RE: **Drive Thru Restaurant**  
**700 Coors Blvd NW**  
**Grading Plan Stamp Date: 5/15/20**  
**Hydrology File: J11D039**

Based on the submittal received on 5/15/20, it appears that all comments have been addressed and this project is approved for building permit.

RE: 700 Coors Blvd NW Albuquerque, NM 87105  
**Hydrology File No. J11D039**

CESO, Inc. is pleased to submit this letter to you in response to your previous review letter dated 09/23/2019.

Drawing No. **GD1.0**

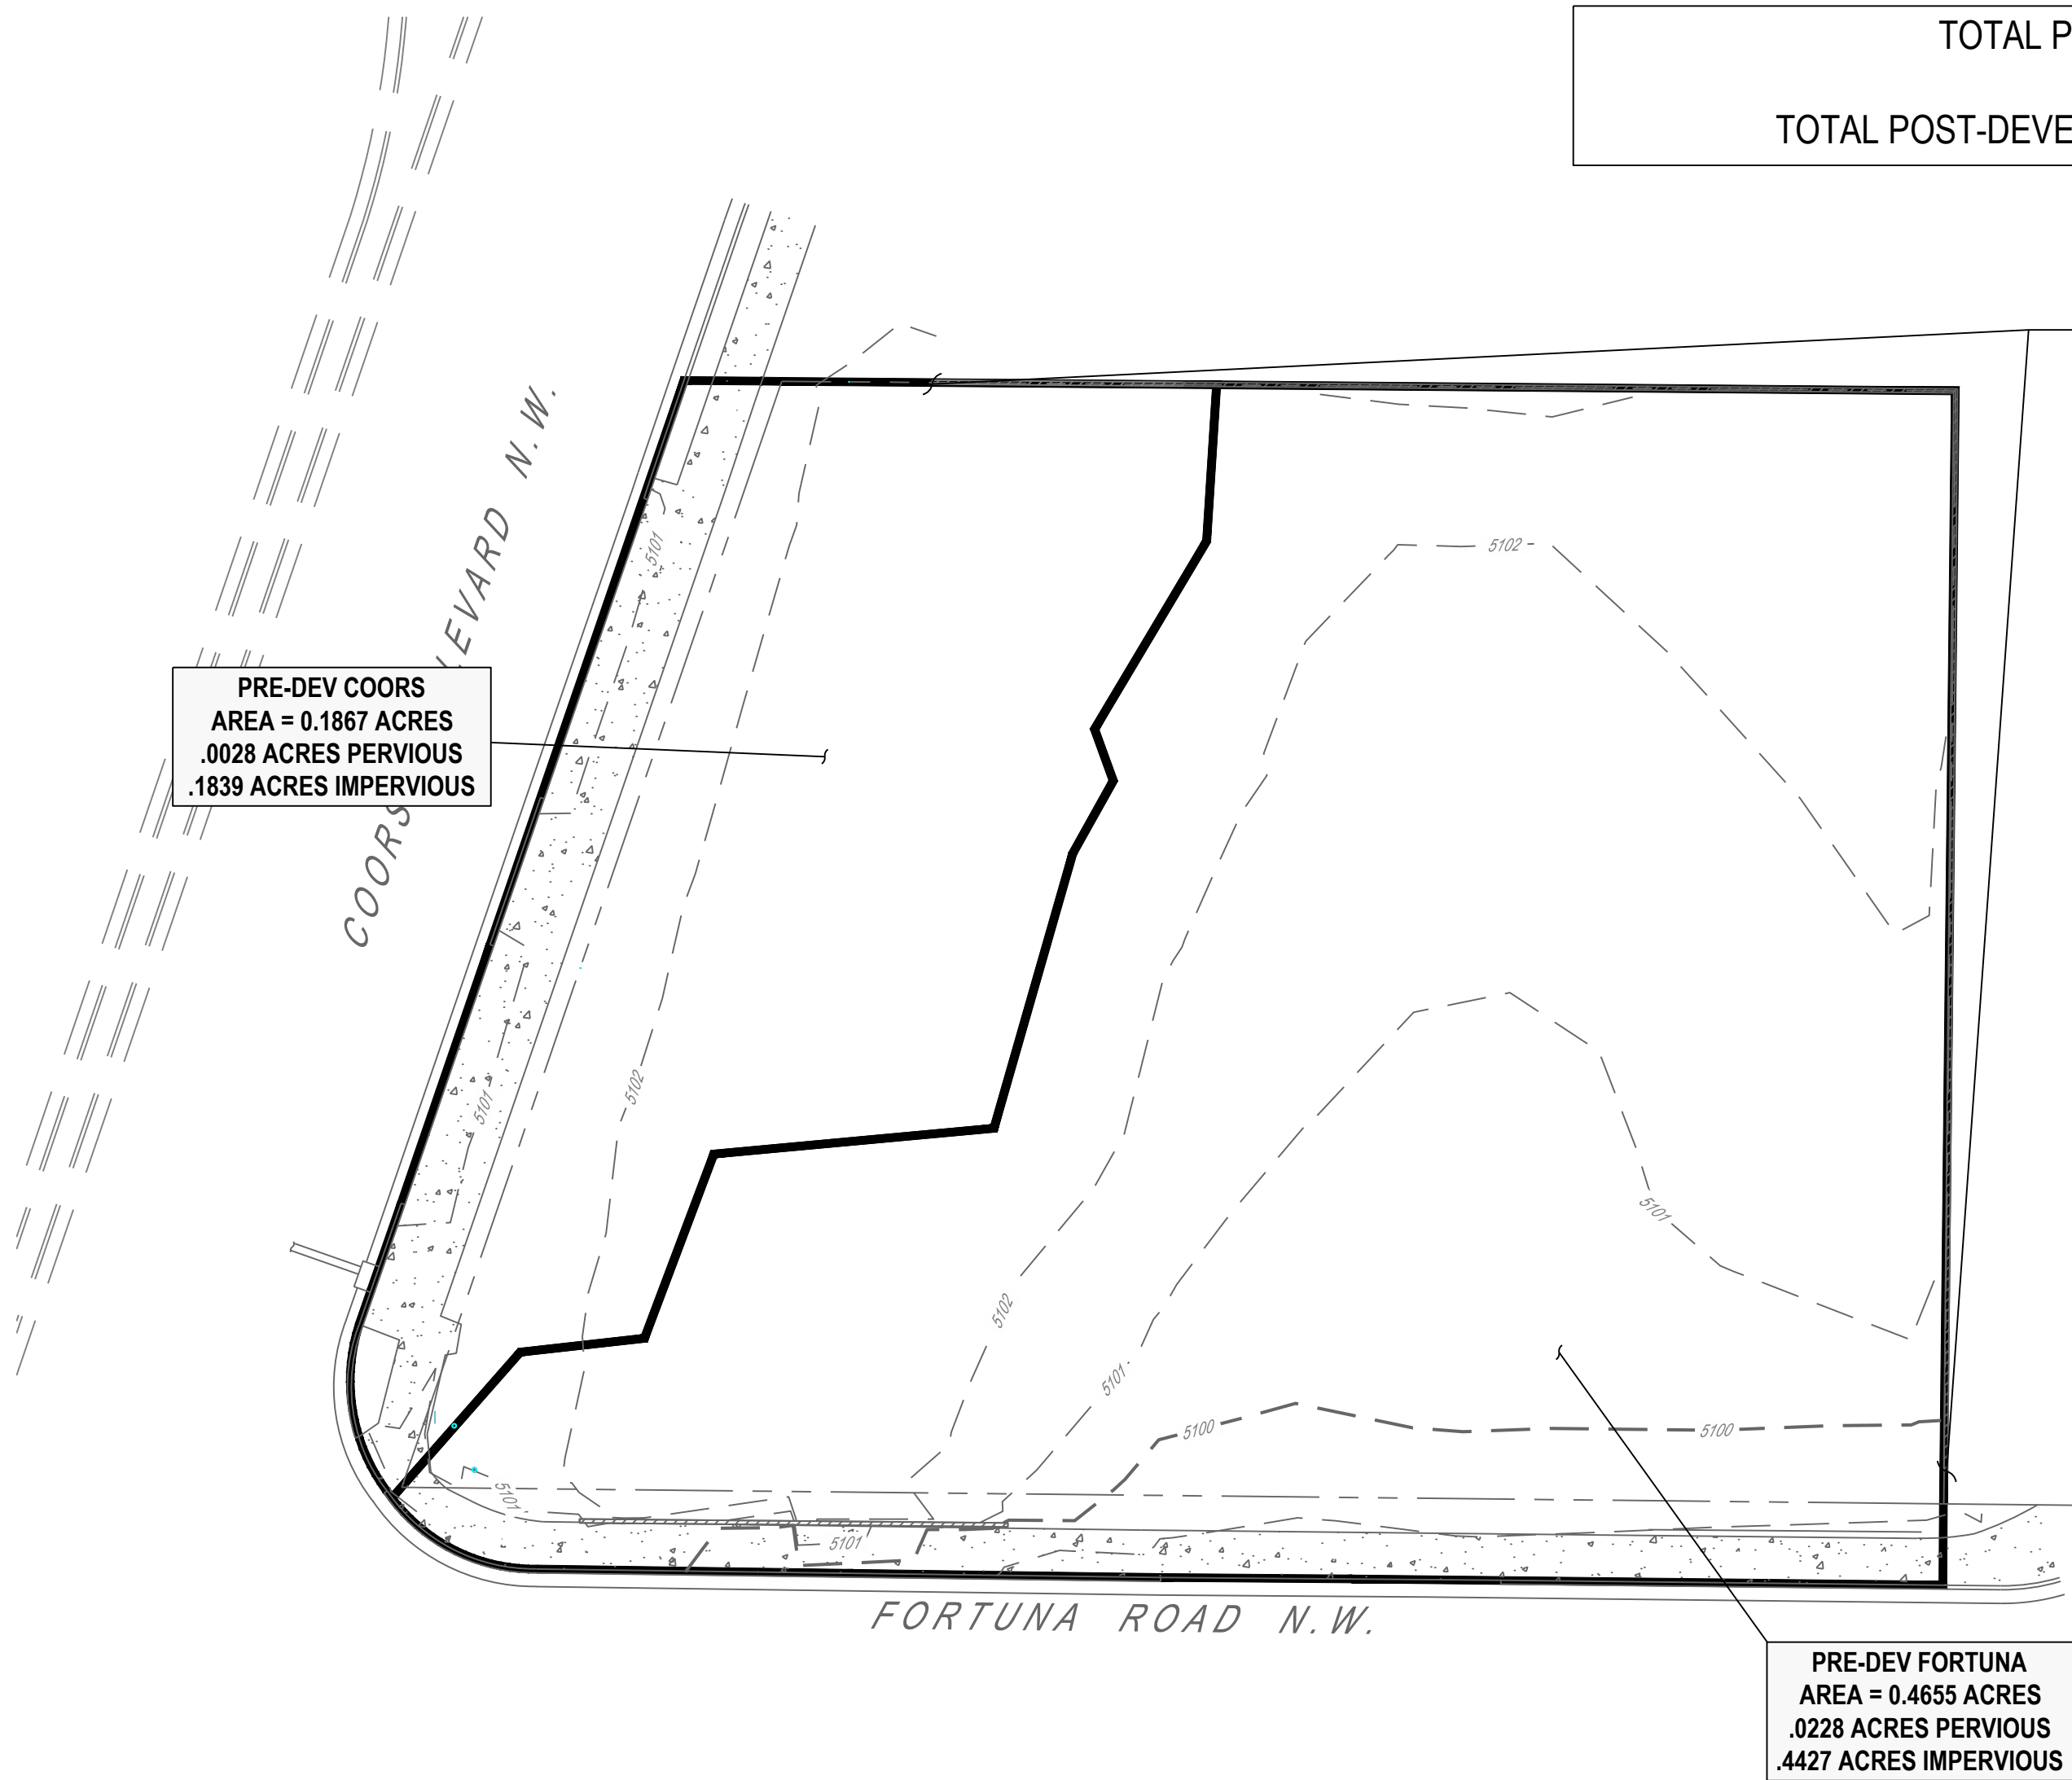
1. Runoff from impervious areas needs to be routed into the stormwater quality (SWQ) ponds. Please provide the SWQ volume calculations for each basin draining to each pond. The stormwater quality ponds need to be sized for the areas draining to them. It appears a large portion of the parking lot and roof simply flows out the driveway onto Fortuna.

7. Show the work to close the extra driveway cut, reconstruct the remaining two driveways per ADA requirements, and any other work required in the ROW. Include spot elevations at flowline and highpoint, demonstrating a 0.87' (min.) waterblock.

8. Add a note on the Grading Plan, "Prior to any work within the New Mexico Department of Transportation (NMDOT) Right-of-Way, an NMDOT permit will be required." Provide a copy of the issued permit prior to requesting Certificate of Occupancy.

**Response: Stormwater Quality ponds have been added to the site to comply with City regulations. See Sheet GD1.0 and GD1.1 for reference.**

**Response: Spot elevations and notes to close extra driveway cuts have been added to sheet GD1.0 per comment.**

**Response: Note added to Sheet GD1.0 per comment.**

GD1.1

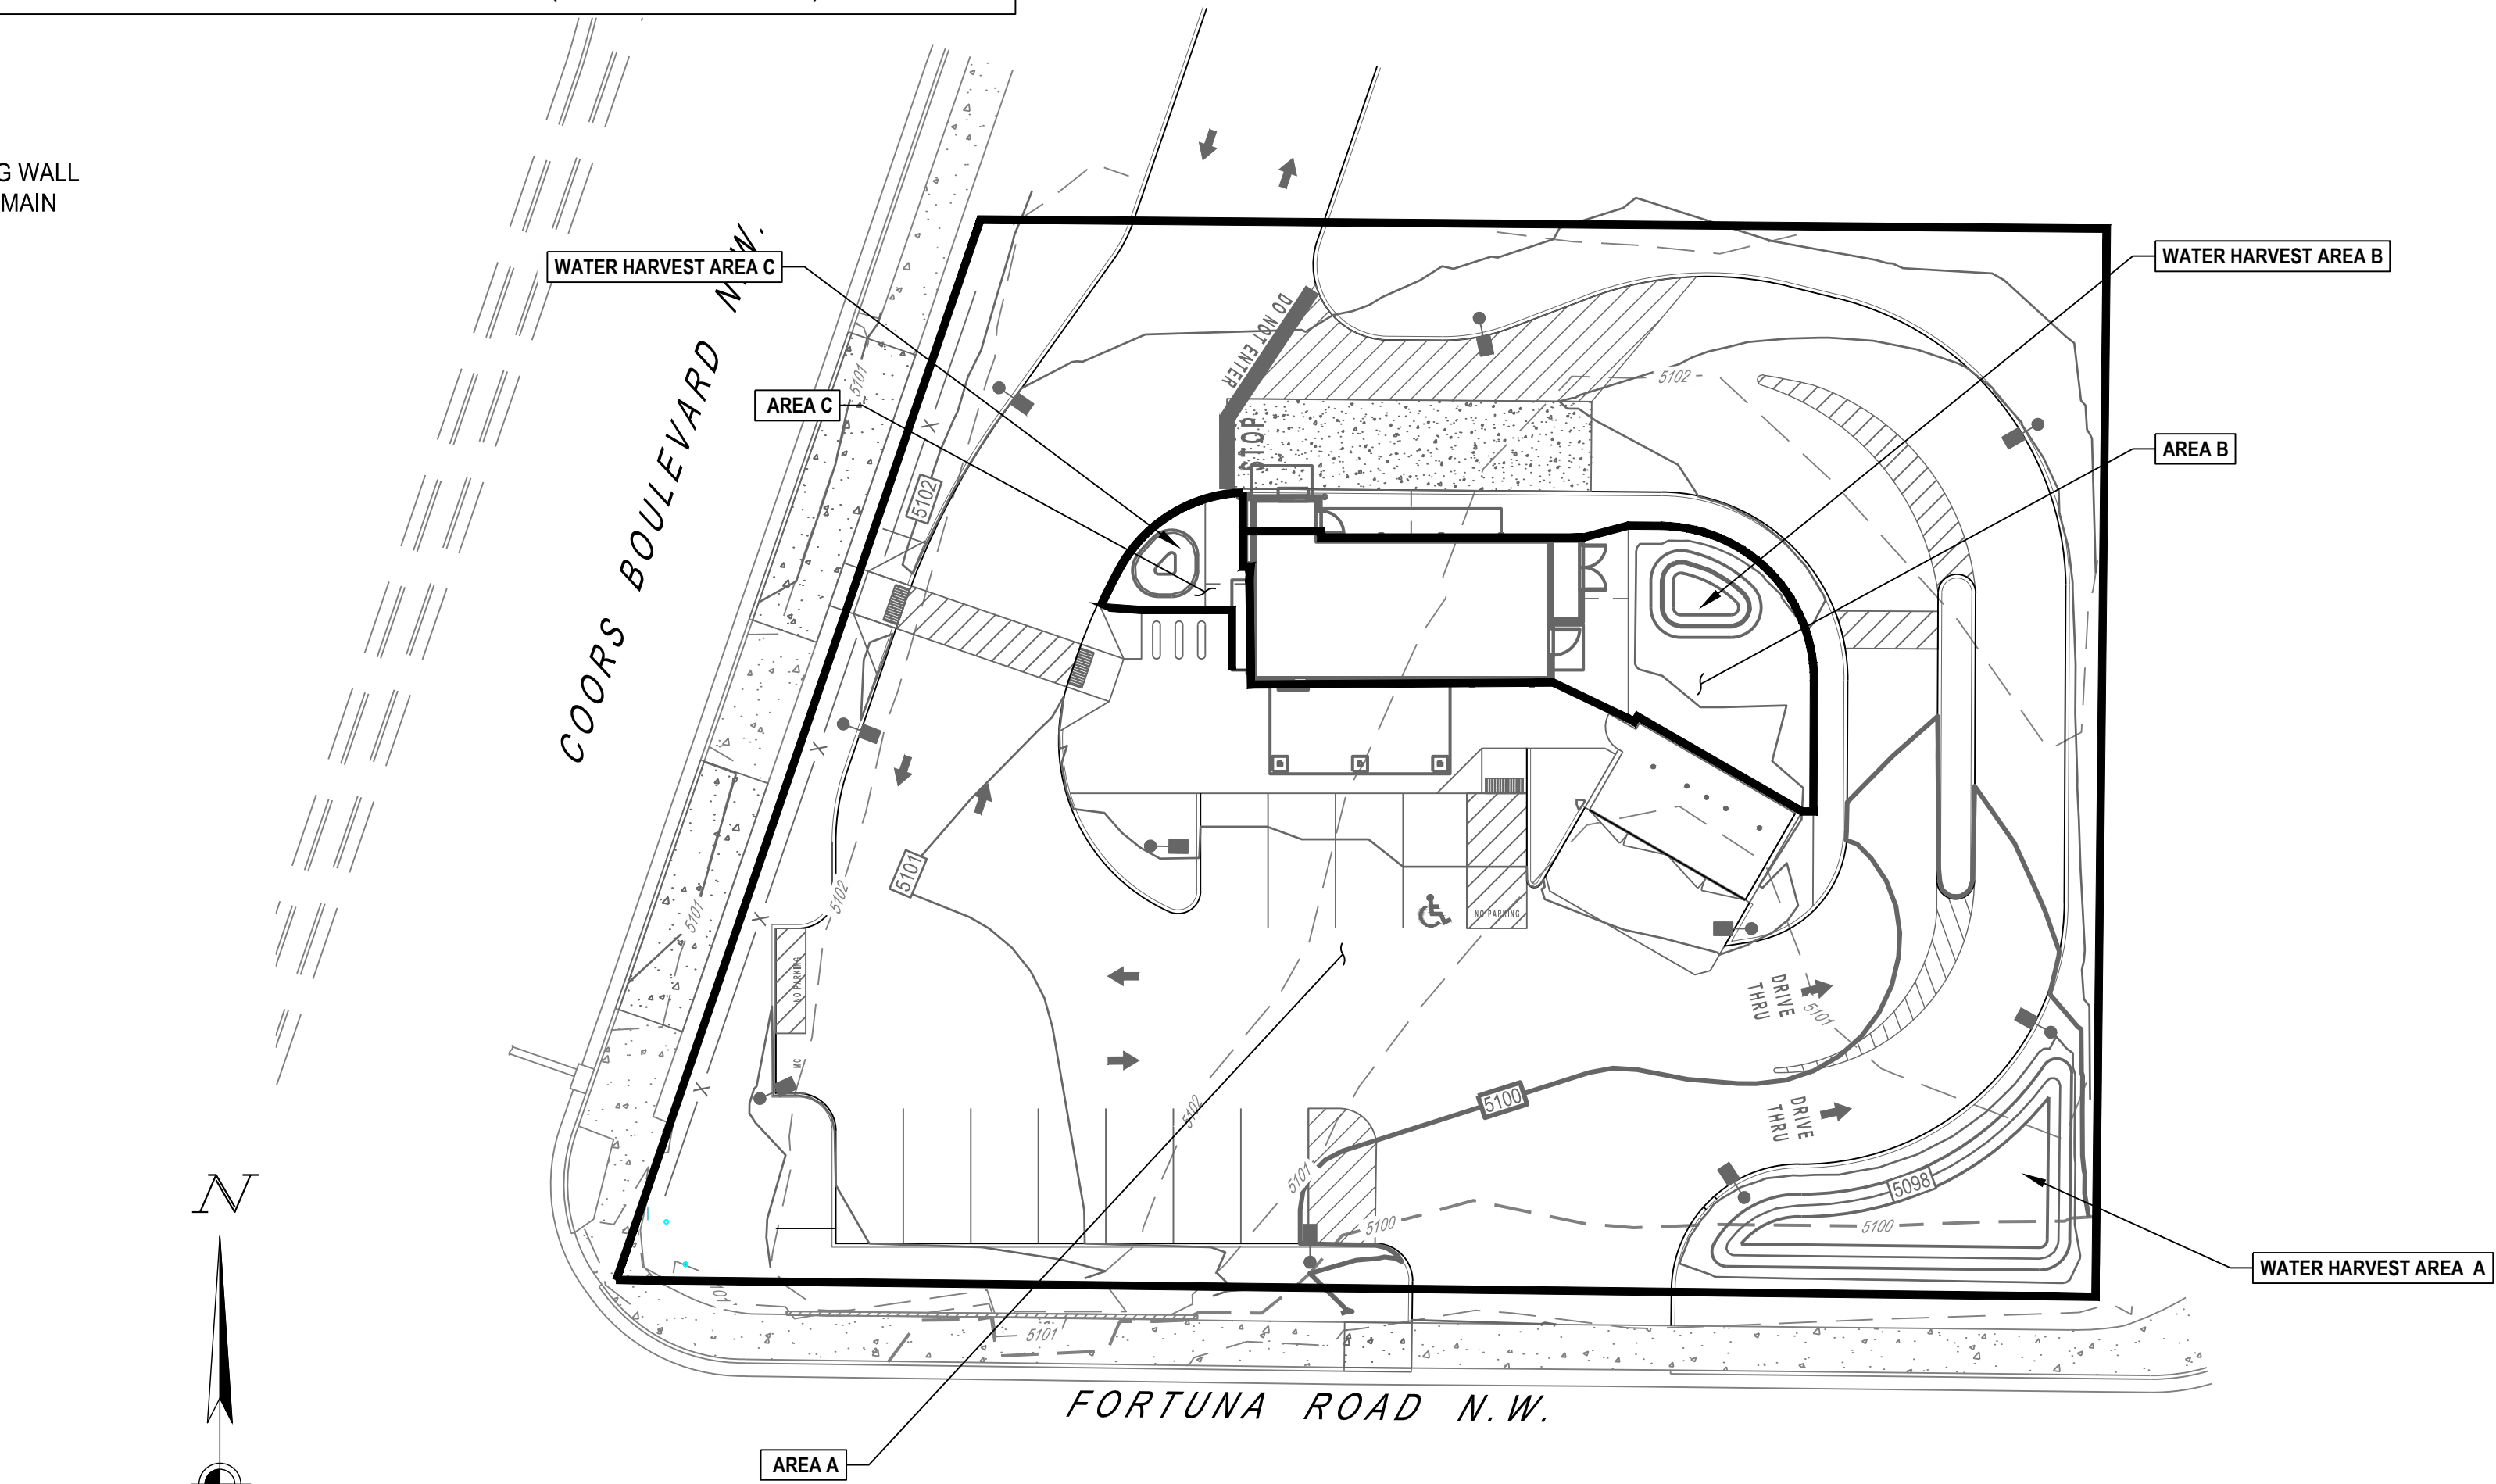
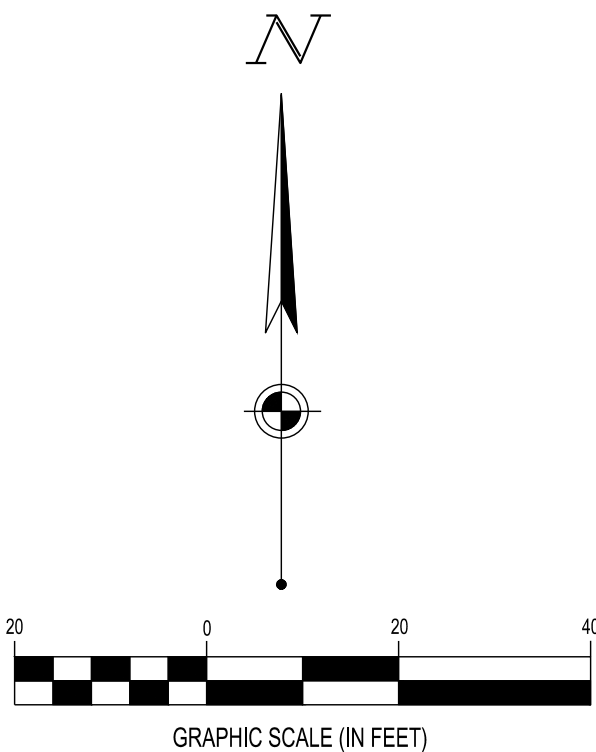
3. Provide hydrologic calculations per the DPM, Ch 22.2.A for the 100-yr storm. Also, a brief narrative describing the project and existing/proposed grading and drainage is recommended (DPM Ch 22.7: *Grading Plan Checklist*).

4. Provide outfalls for both ponds, sized for the 100-yr peak inflow. Include supporting hydraulic calculations as needed.

**Response: This has been added to the plans on Sheet GD1.1.**

**Response: The ponds are designed as retention ponds to provide rainwater harvesting. Hydraulic calculations are provided on Sheet GD1.1.**
